Response to RC1:

Response to RC2:

Figure C1 Comparison of DAD curves estimated from vine copulas (solid markers) and ARFs from Kao et al., 2020 (empty makers) for Ohio River Basin with 10-year ARI and 2-72 hours durations.

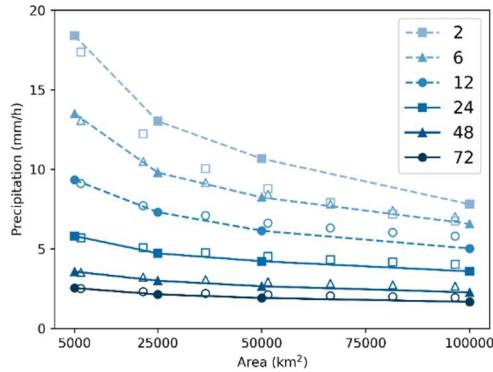
The only comparison to other methods they make is with a GEV fitted to storm annual maxima in Figure 6-7. I believe there is also opportunity to compare DAD curves in Figure 8 to an external data sources. The authors mention the relationship between DAD curves and ARFs, so any ARF information available for the Mississippi basin could be used to formulate a comparison here.

A recent study by Kao et al. (2020) provides ARFs for 10-year precipitation with durations of 2-72 hours and areas of 10-100,000 km² in the Ohio River Basin, using a watershed-based approach and gauge dataset. To compare, we calculated new DAD curves by converting the hourly precipitation depth at 5,000 km² from the vine copula model to precipitation depths at larger areas based on the ARFs. We then compared these new DAD curves with the original DAD curves that were purely estimated from vine copulas (see Figure C1 below). The two DAD curves agree well for durations between 6 to 72 hours, while for 2-hour storms the vine copula estimates are more conservative, i.e., the precipitation depth reduces much slower than the ARF estimates when area increases. Such discrepancies may be attributable to the ARF estimation of Kao et al. (2020) being a “fixed-area” approach, i.e., the point precipitation depth is related to areal depth in a watershed. Nevertheless, the number of large watersheds in the Mississippi Basin (e.g., watersheds greater than 50,000 km²) is limited, which may limit the approach’s ability to identify truly areal maxima, especially for short-duration large-area storms. This suggests that our storm searching algorithm may provide more conservative DAD relationships for storms with short durations. An alternative explanation, however, could be that these differences highlight the limits of ERA5 in depicting extreme convective rainfall at small space-time scales. We included Appendix C “Validation of vine copula DAD relationships” (see draft below) and a short discussion in Section 5.3 to describe the above comparison:

The vine copula DAD curve was compared against the ARFs in Kao et al. (2020). The ARFs were estimated for 10-year precipitation with durations of 2-72 hours and areas of 10-100,000 km² in the Ohio River Basin, using a watershed-based approach and gauge-based dataset (DSI-3240, National Climatic Data Center, 2003). We calculated new DAD curves by converting the vine copula hourly precipitation depth at 5,000 km² to the depths at larger areas based on the ARFs. The new DAD curves were then compared with the original DAD curves estimated from vine copulas, as shown in Figure C1. More discussion of this figure can be found in Section 5.3.

“...The ability to derive storm-centered DAD relationships using our method can in principle obviate the need for ARFs entirely, something that has been advocated for previously (Wright et al., 2014). To support this point, we compared vine copula DAD curves with those estimated by the ARFs from Kao et al. (2020) in the Ohio River Basin at 10-year ARI (see Appendix C and Figure C1). The vine copula DAD estimates agree well with those ARF estimates for storm duration between 6 and 72 hours, while for 2-hour storms from the vine copula estimates are more conservative, i.e., the precipitation depth reduces much slower with increasing area. Such discrepancies may be attributable to the ARF estimation of Kao et al. (2020) being a “fixed-area” approach, i.e., the precipitation depth is compared to areal depth in a watershed. Nevertheless, the number of large watersheds in the Mississippi Basin (e.g., watersheds greater than 50,000 km²) is limited, which may limit the approach’s ability to identify truly areal maxima, especially for short-duration large-area storms. This suggests that our “storm-centered” approach may provide more conservative DAD relationships for storms with short durations. An alternative explanation, however, could be that these differences highlight the limits of ERA5 in depicting extreme convective rainfall at small space-time scales. Another contention within the ARF literature is whether or not such ratios are independent of recurrence intervals (e.g. Greener and Roesch, 1997; Osborn et al., 1980; Pavlovic et al., 2016). Relevant to this debate, we found that DAD appears to be independent of recurrence intervals for 5,000-100,000 km² scales in the Mississippi Basin.”
